Interactive comment on “Improving estimates of water resources in a semi-arid region by assimilating GRACE data into the PCR-GLOBWB hydrological model” by N. Tangdamrongsub et al.

Received and published: 9 November 2016

Fig. 1. Figure R1. Regression analysis between GRACE-GLDAS and adjusted well measurements in 5 different locations.

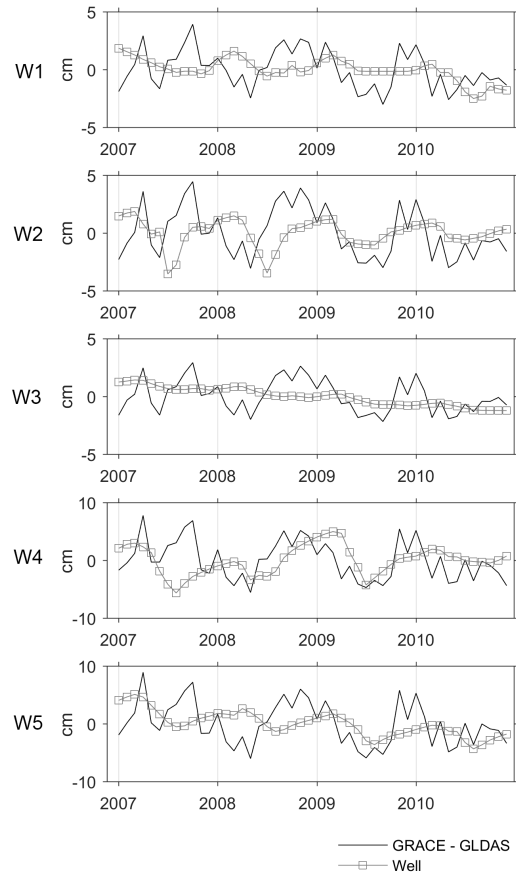
L317-318: Please provide a figure with the data and the regression.

R33: The figure of the regression analysis is shown below (please see Fig. R1). To reduce the redundancy, we do not include Fig. R1 in the manuscript, but instead we will include a discussion of the parameter estimation in the revised manuscript as follows: “Yang et al. (2001) showed that the specific yield values obtained from the field measurements over the Shiyang River Basin was between 0.01 and 0.3. Although, the measurement was not conducted at the well stations used in this study, the values obtained can be used as a guidance of the specific yield of the Shiyang River Basin. In this study, the head measurements were converted to storage unit with the approach described in Sect. 4.3.1. The bias term in Eq. (3) was found to be very close to zero, as the variation (mean removed) was used in the regression analysis. The estimated scale factor was 0.23, 0.04, 0.24, 0.25, and 0.32 at W1 – W5, respectively, which was in line with the values obtained from the field measurement.”

Fig. 2. Figure R2. Monthly total precipitation (left) and SM storage estimates of September 2007 and 2008. Stream gauge location G2 is also shown.

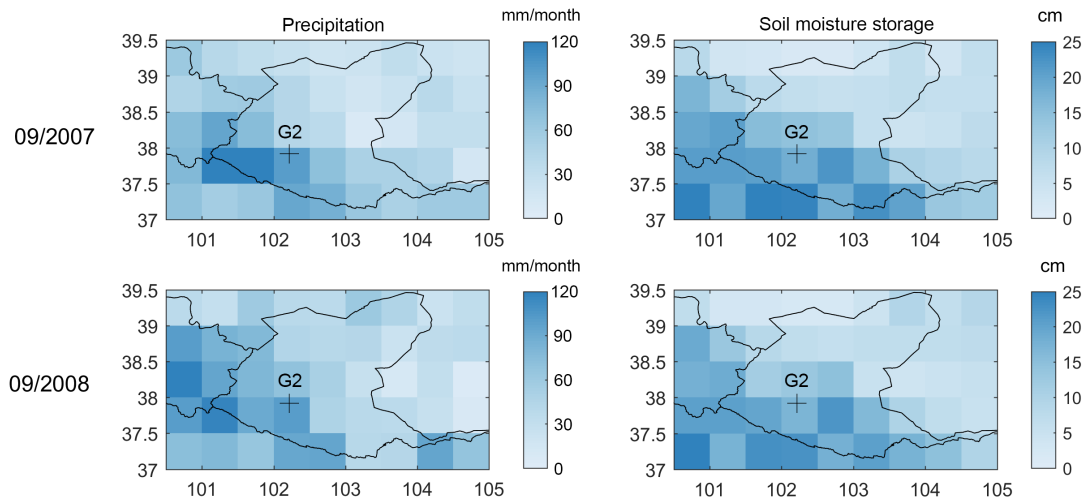
L647-648: These are very low amounts of precipitation, indicating very local precipitation events. It would be interesting to see the spatial distribution of these rainfall events and the resulting modelled soil moisture distribution.

R43: The maps of rainfall and SM storage estimates of the discussed events (September 2007, 2008) are shown below (please see Fig. R2). However, this is beyond the scope of this study, and therefore Fig. R2 is not presented in the manuscript.
